Product Support Bulletin 2009-005

Maintenance of Way ~ Work Equipment Bulletin

SUBJECT: Dust Hood Bumper Pad Material Change – 52890001

**MACHINE
MODEL(S):** CX Hammer

Figure 1
Bulk Loader Dust Hood and Bumper Pad

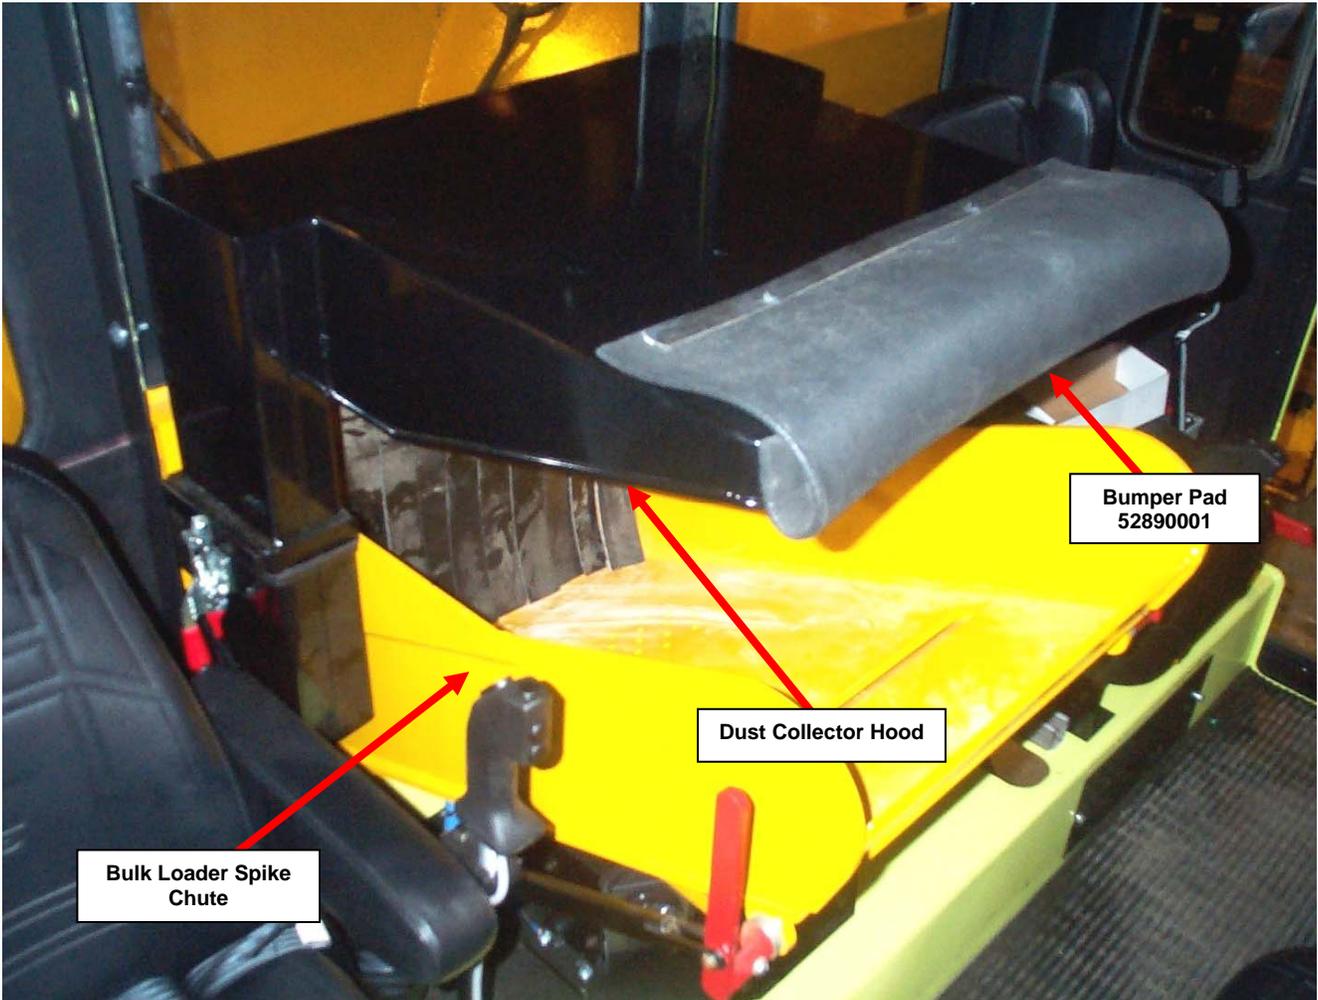
SUMMARY: The 52890001 Dust Hood Bumper Pad is mounted to the end of the Dust Hood in the Operator's Cab to protect the operator from coming into contact with the steel edge of the Dust Hood. See Figure 1 on Page 2. It was originally made of gum rubber. The material has been changed to reinforced neoprene which will increase the service life of the pad.

**OPERATIONAL
IMPACT:** If the Bumper Pad is damaged, the steel end of dust collector is exposed. Possible injury to the operator could result from contact with the steel edge of the Dust Hood.

ACTION: All Dust Hood Bumper Pads should be inspected and if the pad is damaged, it should be replaced with a new pad. To order new pads, contact the Nordco Parts Department at 1-800-647-1724. All new pads are made from reinforced neoprene.
